Access Compliance Report

Public Rights-of-Way

(Curb Ramps)

Intersection ID: N/A	Main Street: RIDGE_OAK_DR	Cross Street: OVERCUP_LN	Location: NW
ADA ID: 259021700DE3	Ramp Type: BlendTrans2	Initial Pass/Fail: Fail	Overall Compliance: No
		Severity Score: 8.75

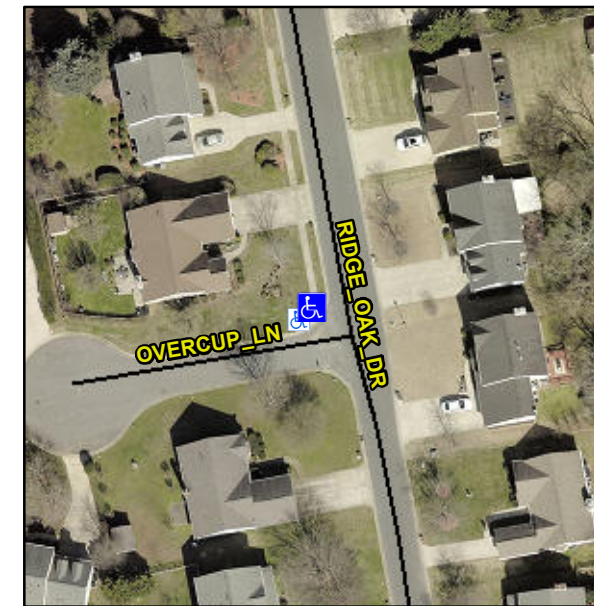
Not Found, R304.5.1

Remove & Replace Curb Ramp With Two New Directional Ramps or Equivalent.
